For Construction Permit for a
New FM Station on Channel 278A
at Marion, Virginia

File No. BPH-910311MA

5 PETITION TO DISMISS OR TO DENY 41

TECHNICAL STATEMENT
IN SUPPORT OF A PETITION TO DENY
THE FM APPLICATION OF JAMES KILLINGER CORNICK
FOR A NEW FM STATION AT MARION, VIRGINIA
PREPARED FOR
COPE II BROADCASTING PARTNERS
MARION, VIRGINIA

Figure 1

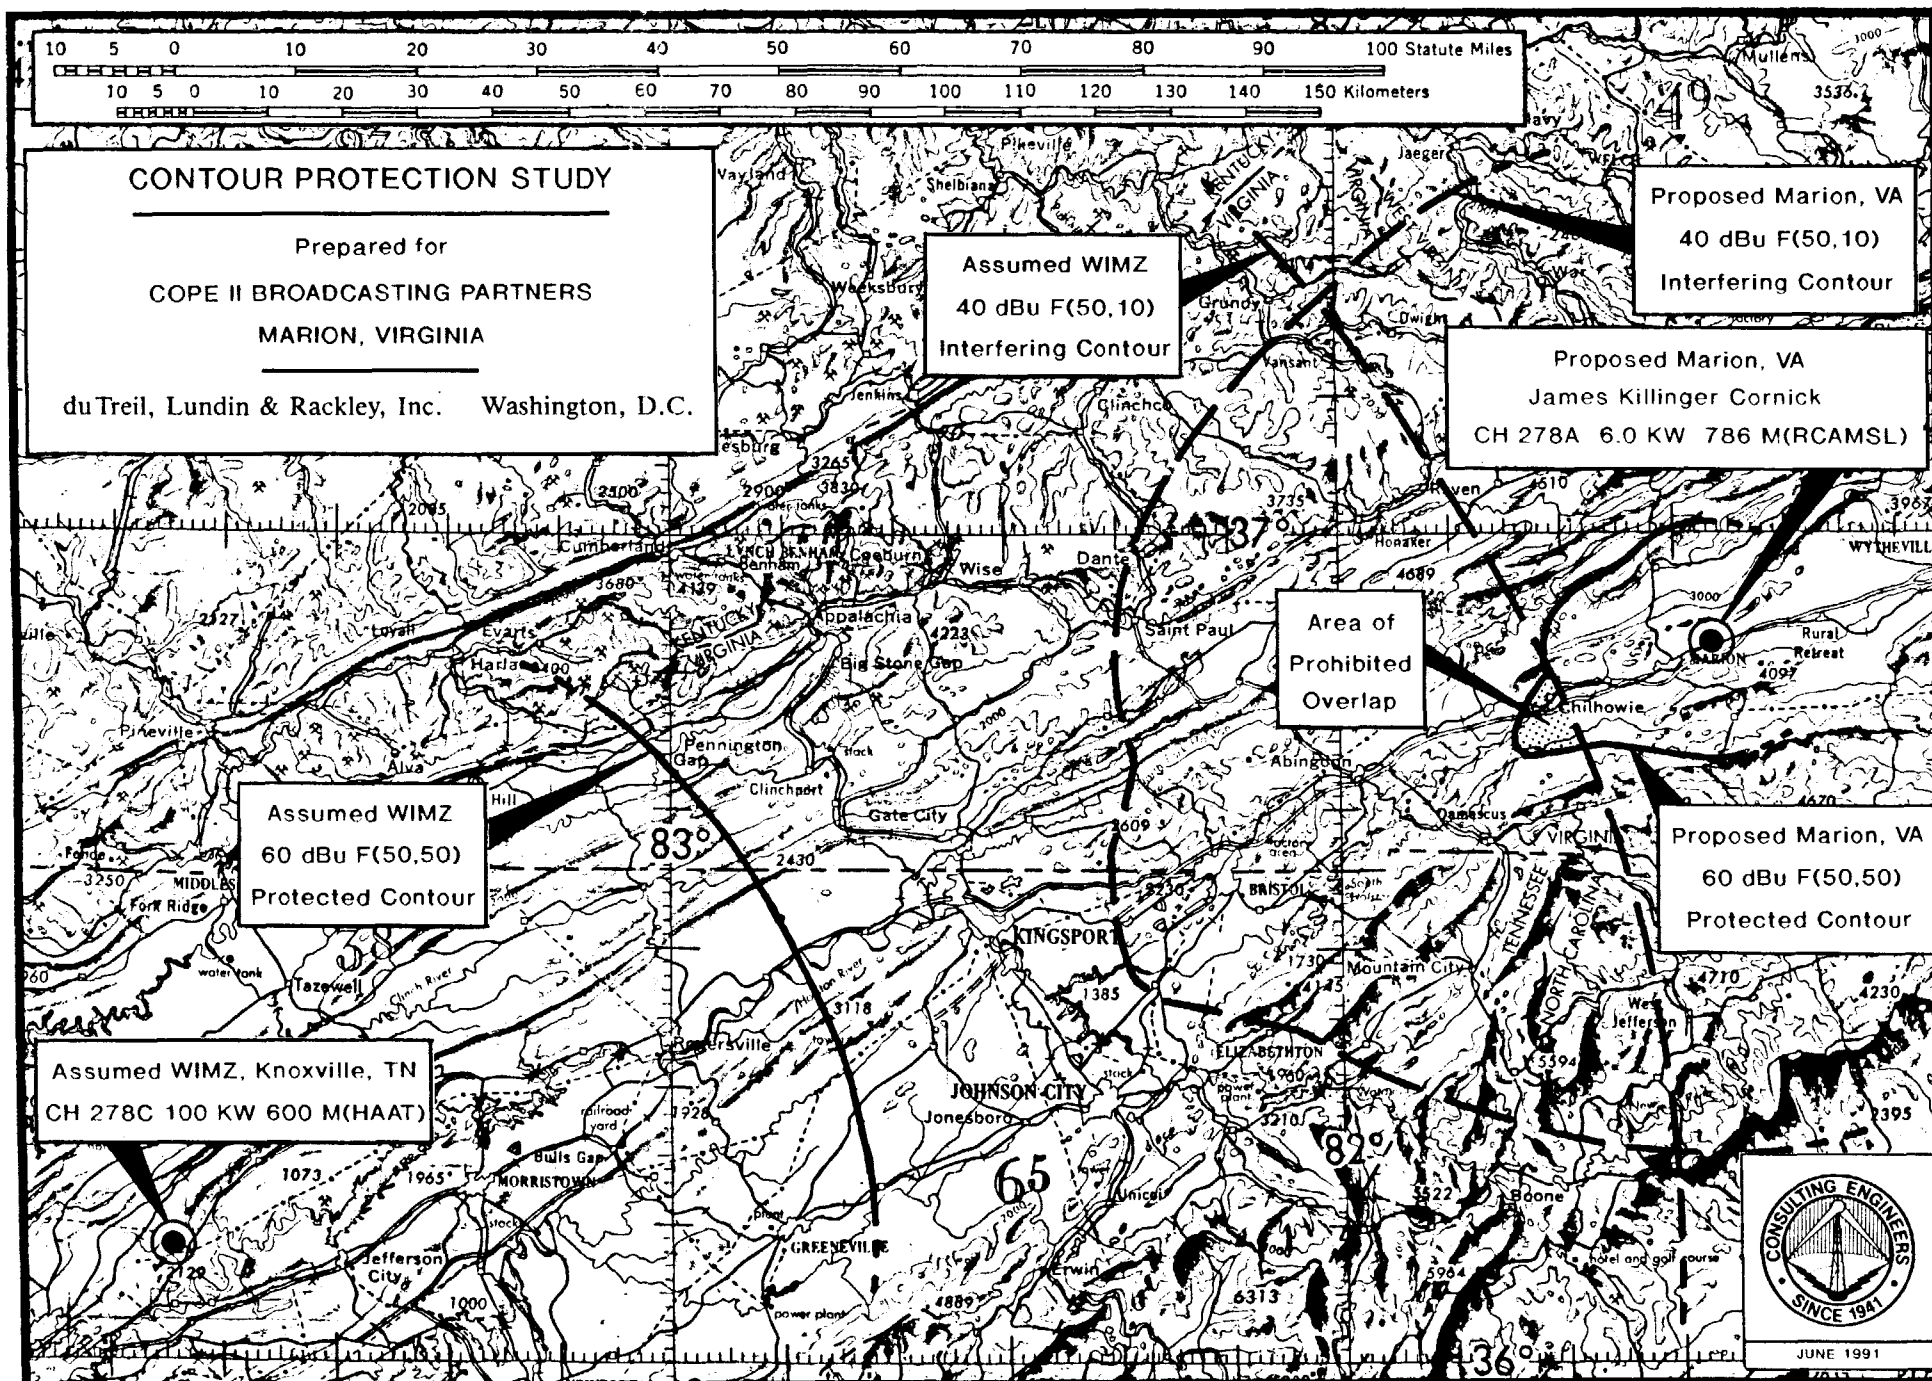
Figure 1 is a contour protection study showing the protected and interfering contours for the assumed WIMZ-FM facility and the proposed facility of James Killinger Cornick. As can be seen, there is a substantial area where the 40 dBu [F(50,10)] contour of the assumed WIMZ-FM overlaps the 60 dBu [F(50,50)] contour of Mr. Cornick's proposal. Attached as Figure 2 are tabulations of the data employed in the contour protection study.

From the tabulation in Figure 2 for the assumed WIMZ-FM facility, it can be seen that the antenna height above average terrain along the bearing from the WIMZ-FM site to the site of Mr. Cornick's proposed facility (68° true radial) is approximately 607.8 meters as opposed to 263.35 meters as stated in "Exhibit E-2 - Figure 6" of Mr. Cornick's proposal. As a result of understating the antenna height above average terrain along this radial, Mr. Cornick's contour protection map ("Exhibit E-2 - Figure 5" of his application) shows a considerable indentation in the contours for his assumed WIMZ-FM facility in the direction toward his proposed facility. Therefore, Mr. Cornick's contour protection map is in error, and prohibited contour overlap is predicted to occur as is shown in the attached Figure 1.

data base that was used for the antenna height above average terrain along the 68° true radial in determining the distances to the WIMZ-FM contours shown in the attached Figure 1.
